**COUNTY OF RIVERSIDE**  
**GATE AND FENCING PROJECT AT LAKE HILLS FIRE STATION #82**  
**RFB# EDARC-070**

**ADDENDUM NO. I**  
**DECEMBER 04, 2018**

**ADDENDUM NO. I**  
**TO RFB # EDARC-070**

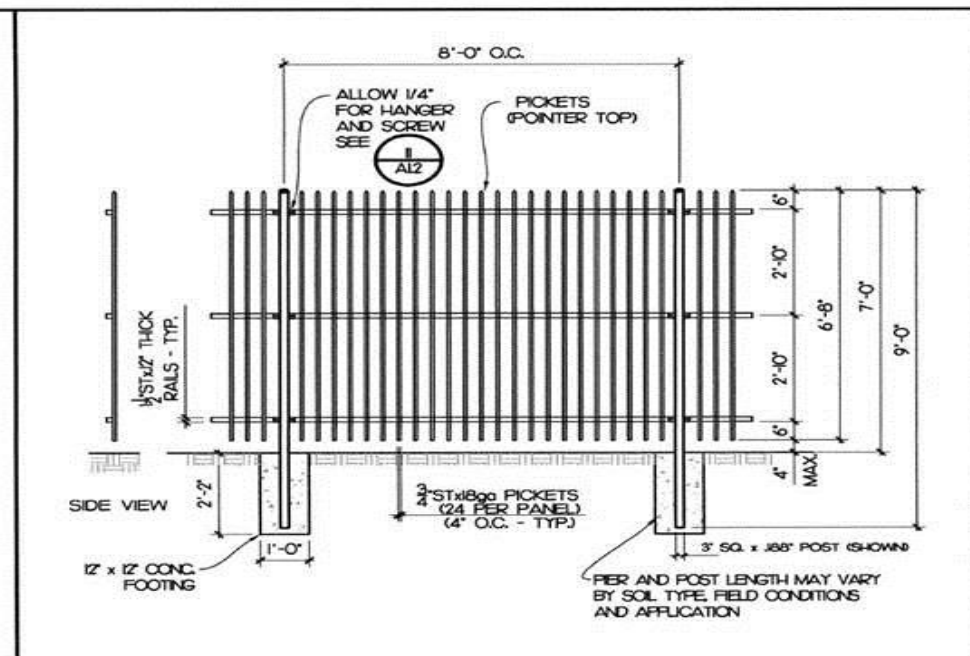
**Question #5:** Gate operator must have a "mouse proof enclosure" see specifications. There are currently no specifications in any of the contract documents regarding the gate operator other than it being 1 HP and having a mouse proof enclosure.

**County of Riverside Answer:** Cover that comes with gate operator unit is acceptable. See spec section 32 3111 / 2.3 / a.

**UL 325 7th edition**

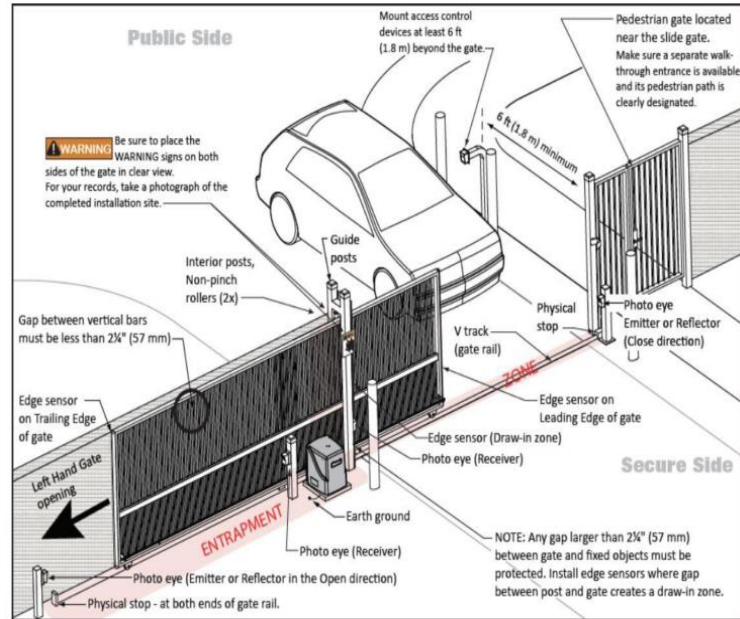
Monitoring of external entrapment protection sensors is required for all automated gate operators manufactured after January 11, 2016. The latest revision, effective August 1, 2018, clarifies and elaborates on these requirements.

- Slide gate operators require two external entrapment protection sensors to operate, one in each direction of travel. Sensors can be either contact (edge sensor) or non-contact(photo eye).

- Swing gates require two external entrapment protection sensors, either contact (edge sensor) or non-contact (photo eye), unless there is no entrapment risk in one direction.

- The photo eyes or edge sensors you install must be approved for use with the specific gate operator installed. Sensors proven acceptable are described in the gate operator's installation manual.

- HySecurity publishes an up-to-date table of the tested and approved photo eyes and edge sensors.
- UL 325 sets the MINIMUM standard of safety. You must also verify that the gate site complies with ASTM F2200. Survey site, usage class, gate type and other conditions. Design and install appropriate external entrapment protection sensors that address all potential entrapment zones.

- Above is the UL Standard for automated gate installation and the diagram as to how the safety devices work. This is required for people. The “edge sensors” are contact sensors which activate after an object or person is struck. The “Photo Eye” is a non-contact sensor. They activate prior to the gate striking an object or person by detecting anyone or thing that is in the path of the gate closing or opening. Again this is required for the protection of people. This system pertains to all Fire Stations not just 54.

5.0 UL 325 7<sup>th</sup> Edition Requirement –Contractors are required to comply.
